# CITY OF ALBUQUERQUE

RE: **Swim Labs**  
**8110 Holly Ave NE**  
**Grading Plan Stamp Date: 8/13/19**  
**Drainage Report Stamp Date: 8/13/19**  
**Hydrology File: C20D082**

Based on the submittal received on 8/13/19, the grading plan and drainage report cannot be approved until the following are corrected:

**RE: Swim Labs  
Grading and Drainage Plan  
Hydrology File: C20D082**

**SWIM LABS**  
**GRADING & DRAINAGE**  
**PLAN**

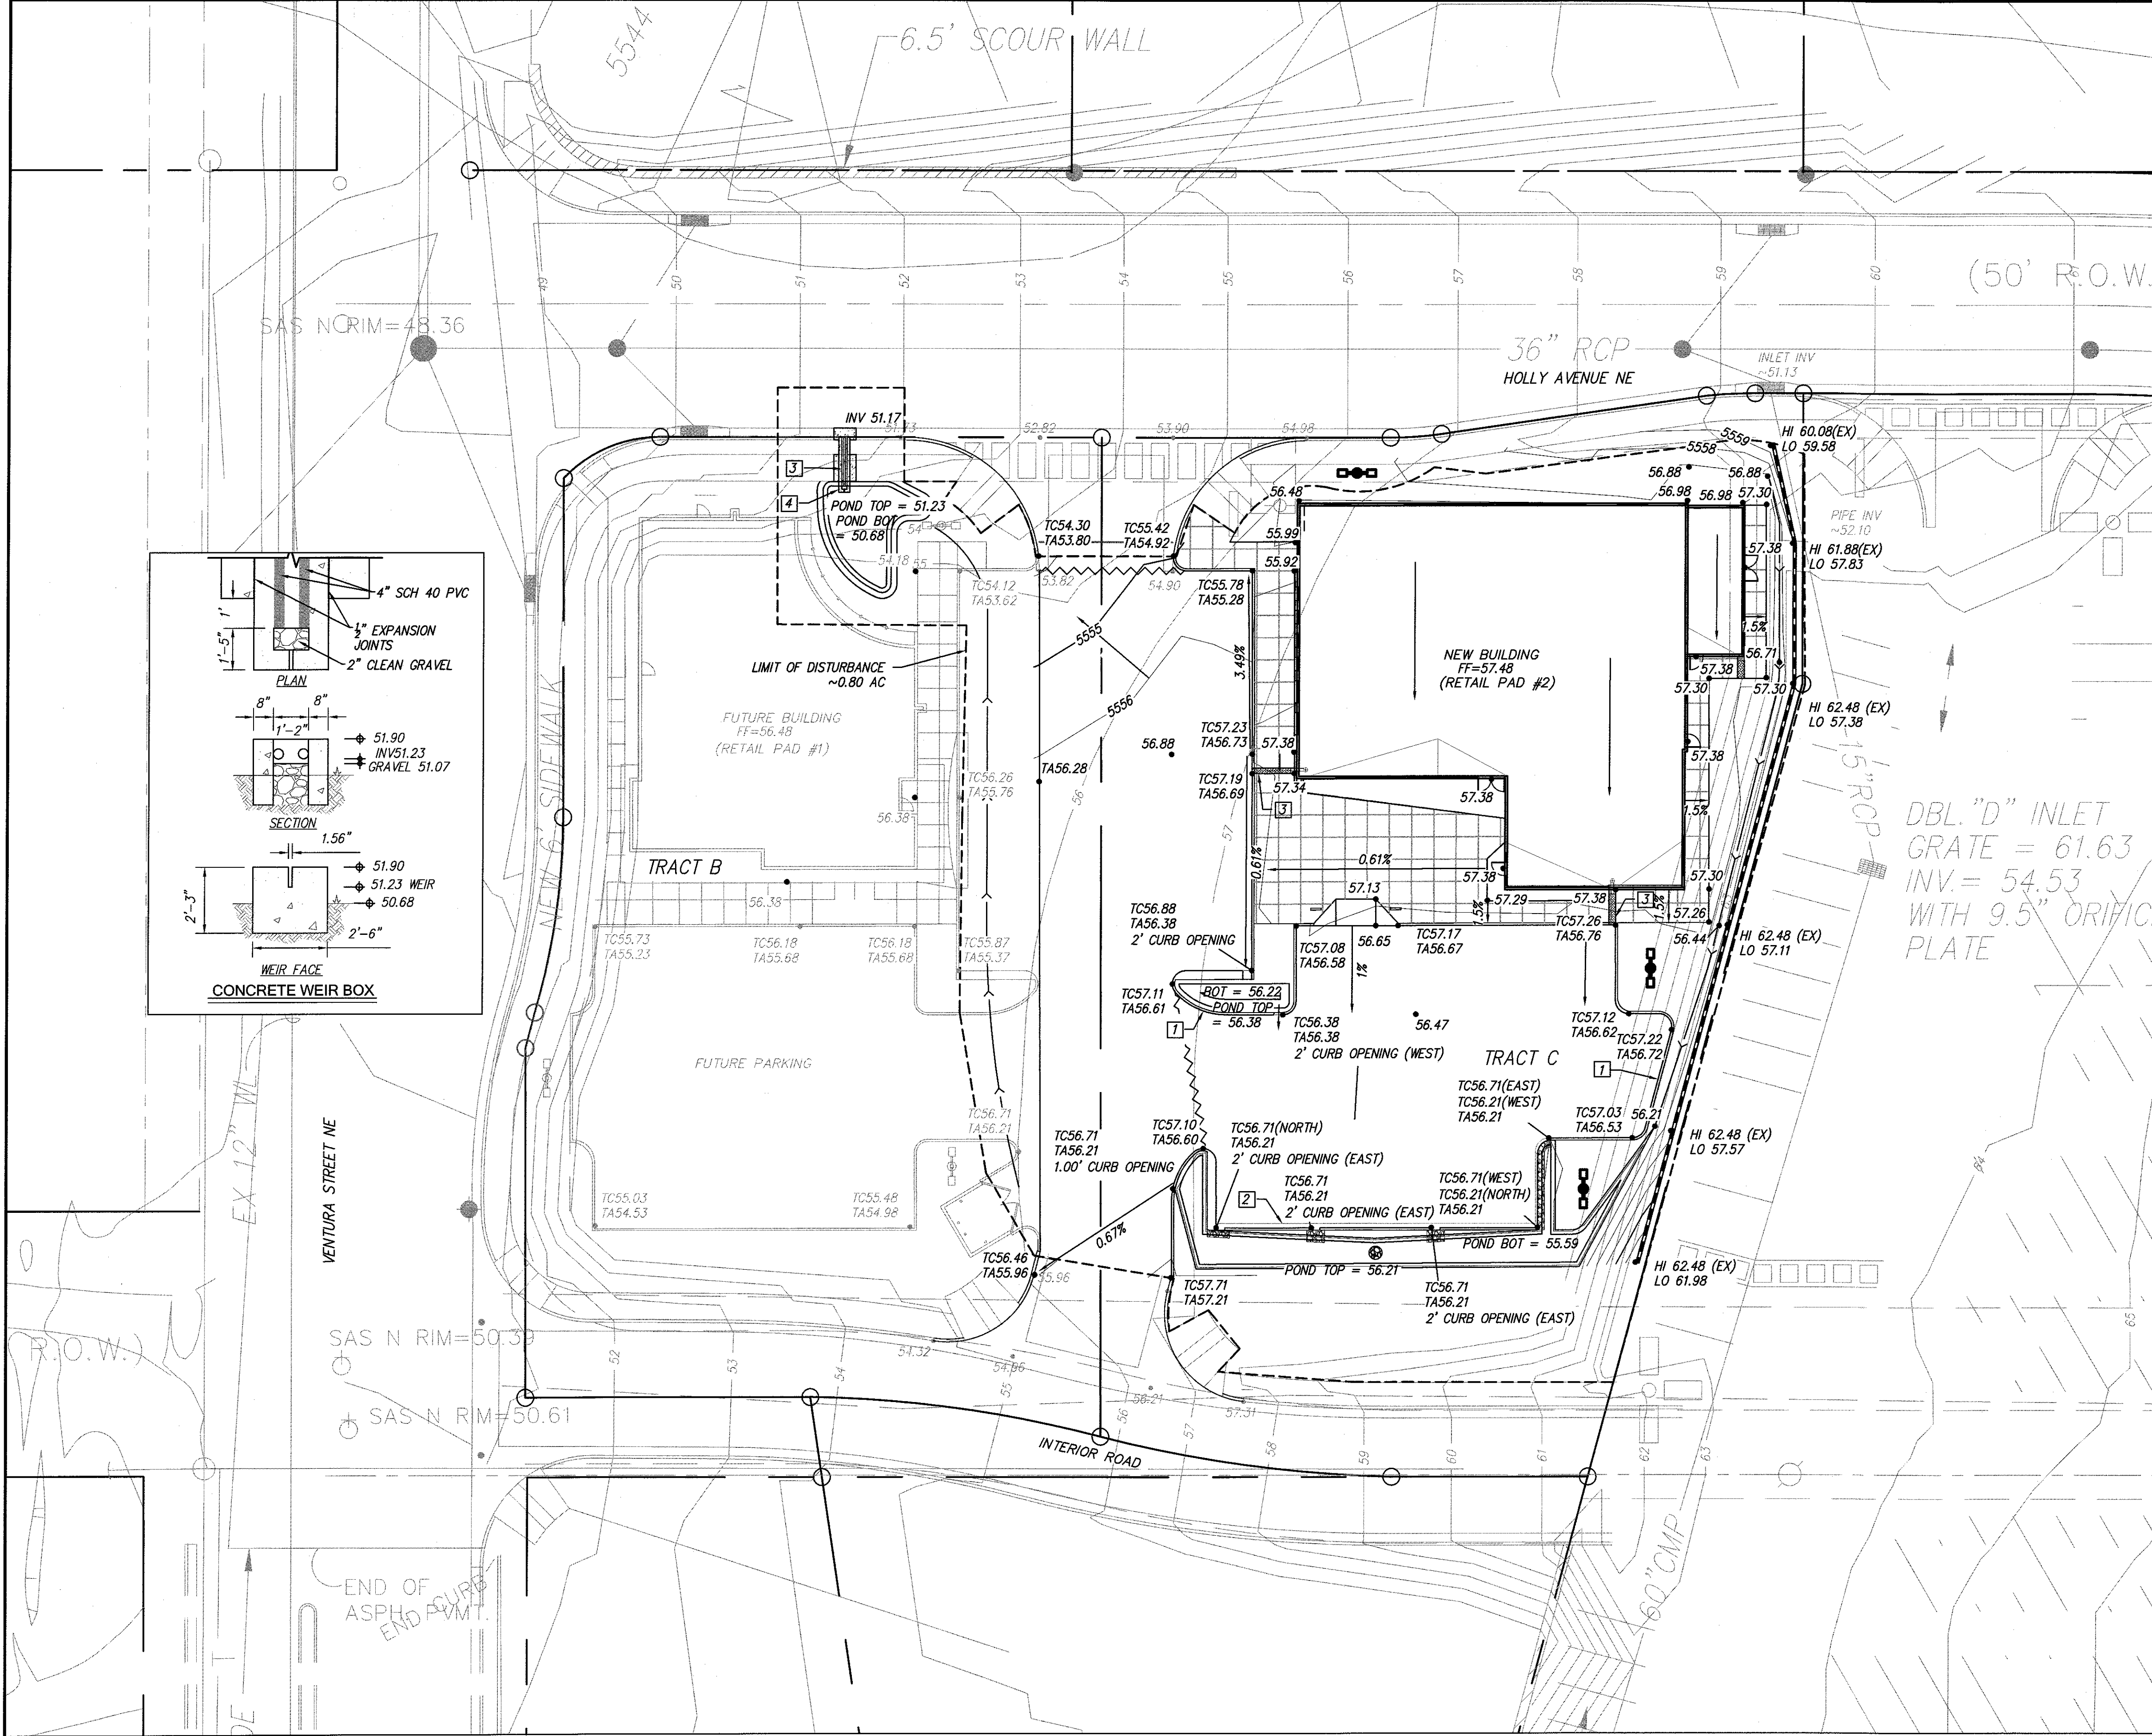
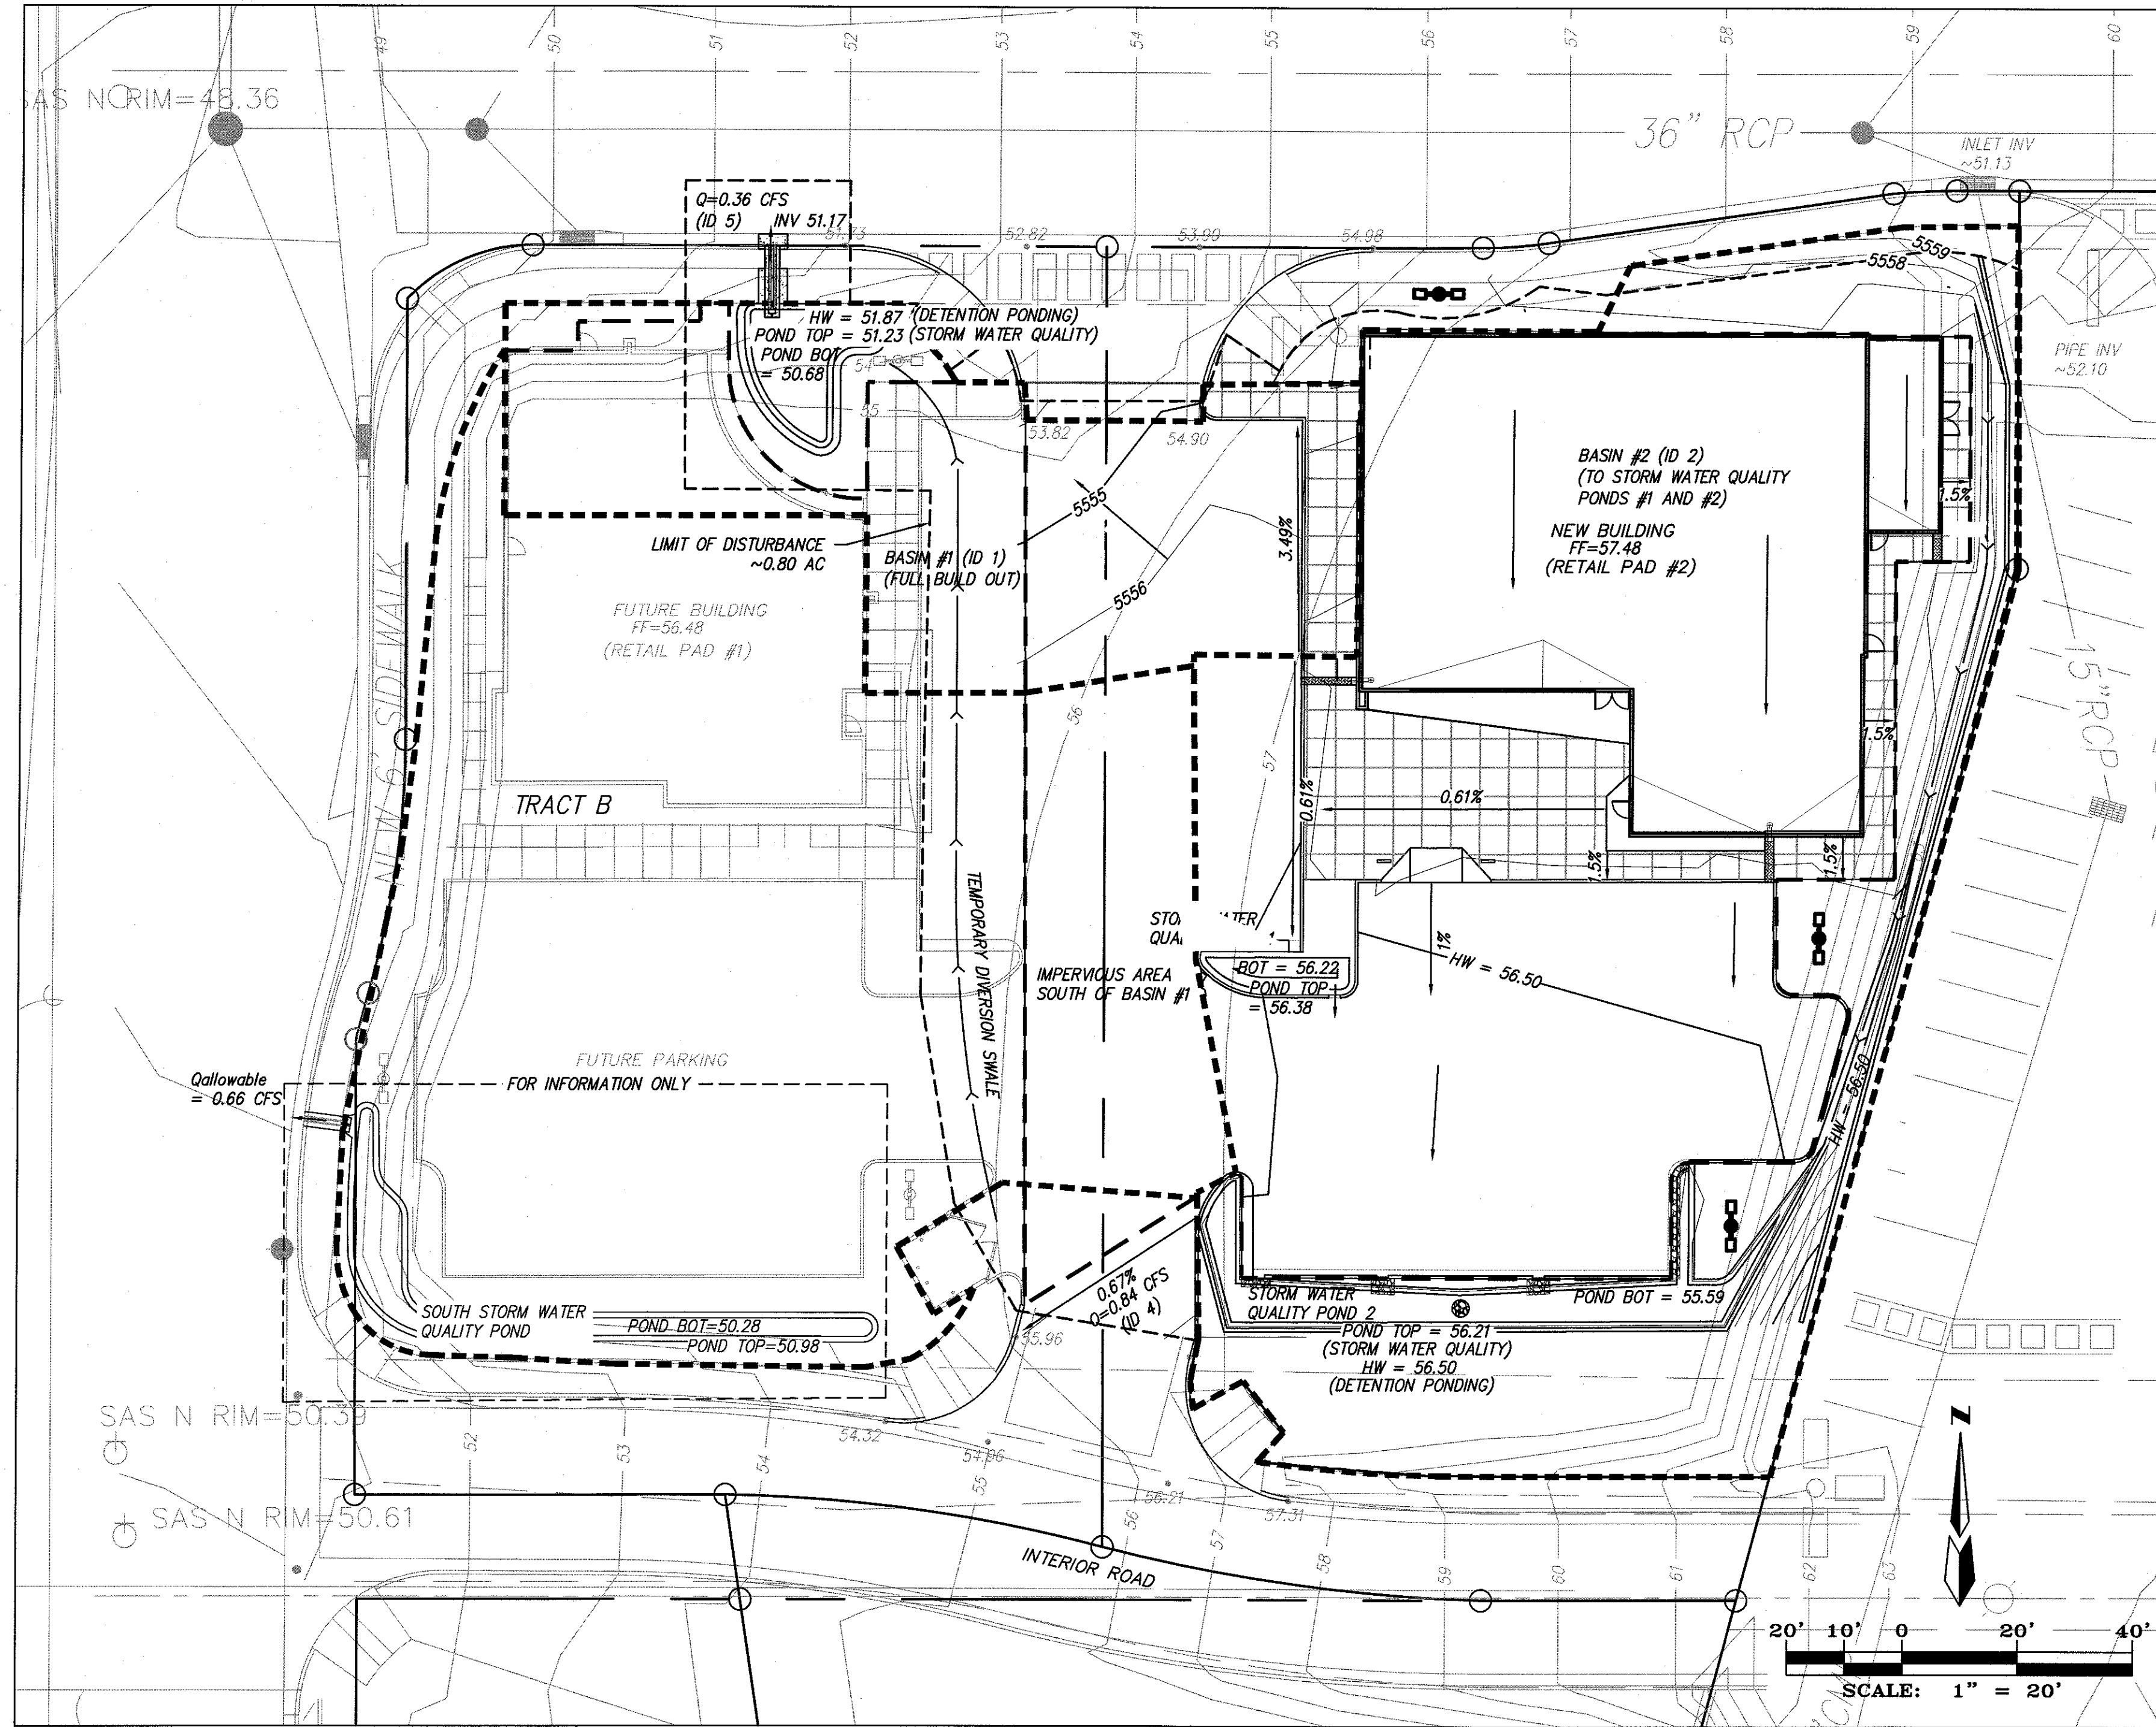
1. Provide written and signed permission from the owner of Tract B for the grading, paving and pond construction on their property. Unfortunately the cross-lot drainage easement does not grant the right to perform work on their property, only to discharge to it. (A permanent pond covenant will also be needed from this owner prior to CO; you may want to get it now). Permissive discharges from the two sites need to be coordinated and included in the agreement as well (1.86cfs max combined).

2. Rainfall amounts need to be input as: 0.0, 1.82, 2.45, 2.86, per the Atlas 14 printout and the AHYMO user manual. Rainfall Type needs to be 2, for a 24-hr storm. You cannot just reduce the rainfall for the 100-yr storm; the pond discharge tables need to include the dead storage for the SWQ volume so the entire 100-yr storm may be modeled and routed.

1. Provide sections through the east boundary showing the proposed retaining wall, property lines, existing and proposed grades. In accordance with DPM Ch.22, section 5 part B, grading and wall construction near the property line may not endanger adjacent property or constrain its use.

3. Include a detail where the retaining wall crosses over the private storm drain; ensure adequate clearance.

5. Provide project datum. This needs to be on the plan where the benchmark is cited. The benchmark, existing survey, and proposed work all need to be converted to NAVD88 and NAD 83.

6. The proposed contours need to be cleaned up. For instance, the 54' contour cuts through the building (FF=55'), the 53' contour seems to be missing, and there appear to be different contours used for the ponds that don't tie-in to anything.

7. Hydrology recommends against using the parking lot as dead storage for ponding water (Pond 2).
8. An SO-19 Permit will be required for the sidewalk culvert and should be included on the request. Please include the [standard SO-19](#) notes on the grading plan.

9. Discharge from this site needs to be limited to 0.93cfs per the approved master plan; do not rob capacity from the adjoiner (Pad 1).
10. Remove the open channel and extend the plate to the curb and 1' beyond back of sidewalk; also remove the non-standard plate detail and build per Std Dwg 2236.

1. A retaining wall section is provided with the proposed retaining wall and property line, with proposed and existing grades.
2. It is noted on the plans that the Contractor is to provide written permission from the adjacent property Owner for any disturbance required for construction.

3. The retaining wall layout was adjusted to parallel the existing storm drain and not cross it. A detail demonstrating the worst-case proximity to the existing storm drain is provided.

5. The existing survey and proposed work is shifted (2.48' higher) to NAVD88 datum. The prior survey to the As-Built survey provided an elevation benchmark of 5476.70 for Albuquerque Control Station "6-C19". Per the COA website the "6-C19" control station NAVD88 elevation is 5479.18. A site specific Horizontal datum may be established in the field utilizing a benchmark such as a property corner.

6. The proposed contours are cleaned up and shifted 2.48' higher.
7. It is noted that Hydrology recommends against using the parking lot as dead storage for ponding water.

8. The sidewalk culvert is changed to a drain line through curb with the SO-19 notes on the Grading and Drainage plan.
9. The design is being coordinated with the property Owners. Per design of both Tracts B and C, there are three discharge locations as indicated. The total discharge of both lots (1.86 cfs) was distributed to each discharge location. Distributed discharge proportional to tributary area to

10. The open channel and the non-standard plate detail is removed. The through curb drain is extended 1' offset the sidewalk edge to a concrete weir box for the detention pond design.
